TT450: STREET STARTER CABLE ROUTING

January 14, 2016

APPLIES TO	SYMPTOMS
All 2015-2016 XG500 and XG750 Models	• Driveability or Performance Concerns • Intermittent or Erratic Electrical Operation

Figure 1. BAS

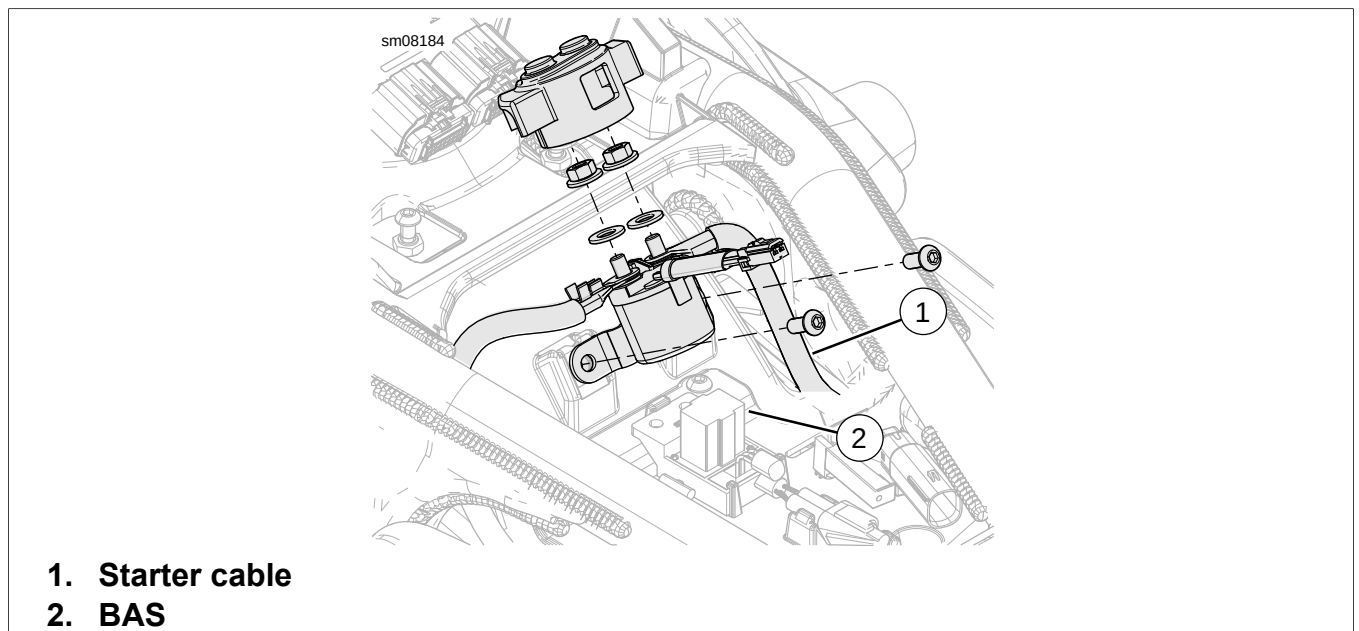
Improperly routed starter cable near the bank angle sensor (BAS) can cause this condition.

See Figure 1. In some cases, the starter cable (1) is routed too near the BAS (2). The resultant electrical interference can cause a false bank angle sensor signal. When diagnosing these issues, verify that the starter cable is routed under the battery box cover.
